**REMARKS**

QUALITY CONTROL IN DATA TRANSFER & STORAGE APPARATUS (30010276)

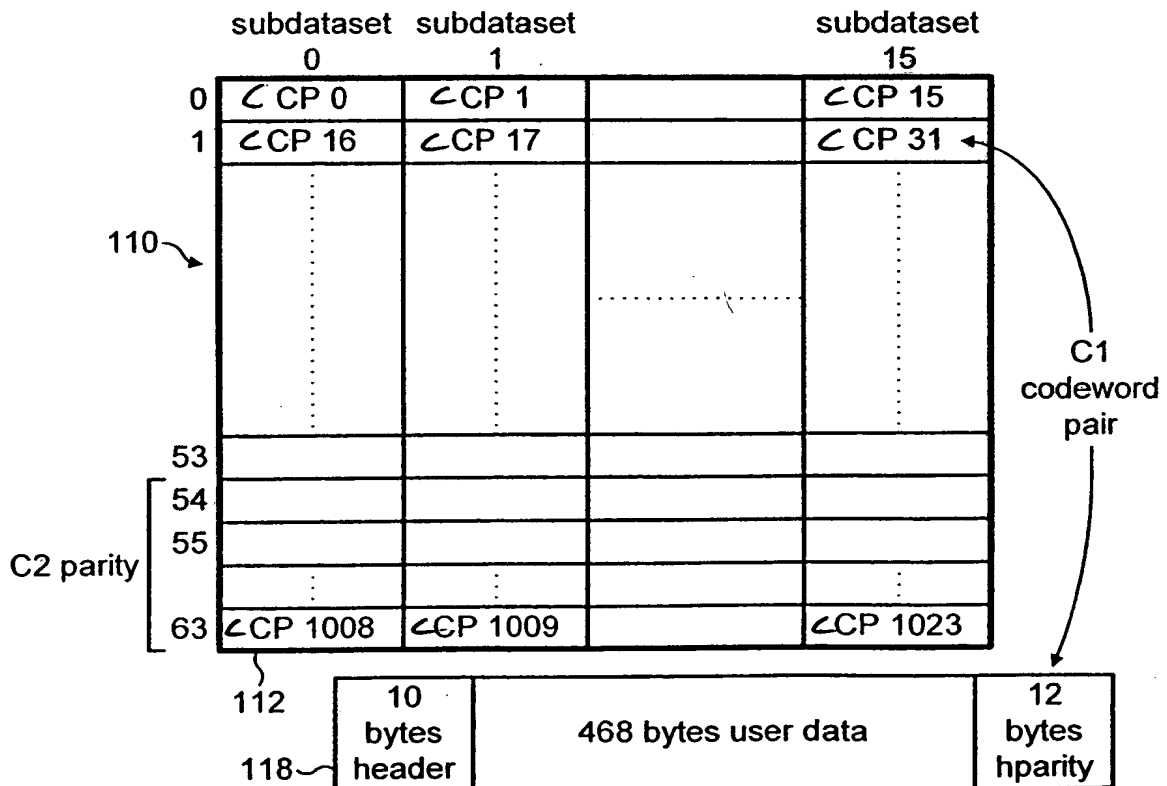
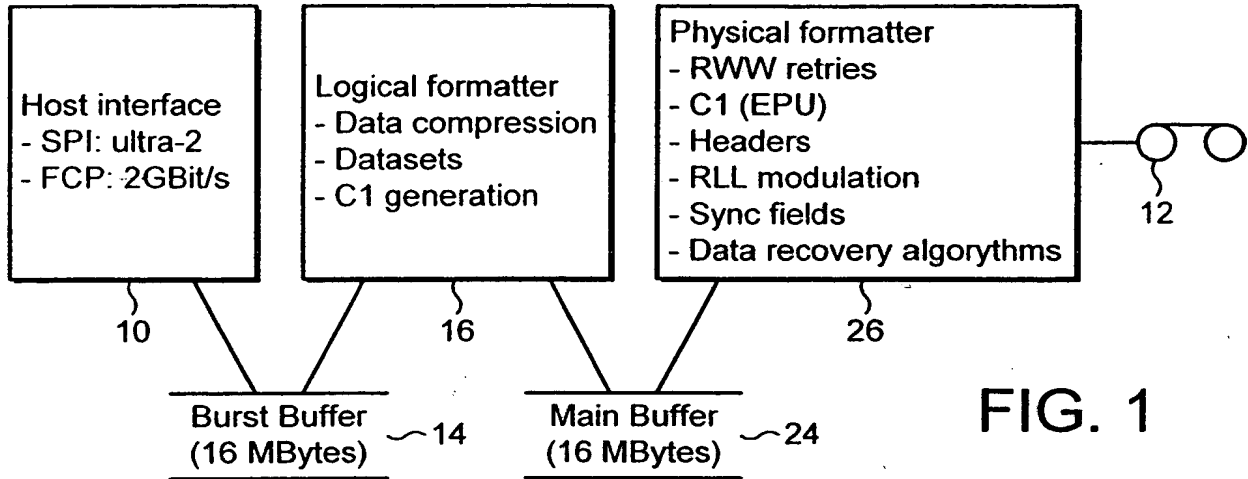
The Examiner is requested to approve changes to the Figures as indicated by red markings. The changes to the drawings enable the drawings to be consistent with the terminology employed in the specification of the application as filed. For example, the specification refers to codeword pairs as "CCP", but the drawings, as originally submitted, refer to the codeword pairs as "CP." Also, the term "CD" in box 32 should have been "CQ" as an inspection of the specification reveals.
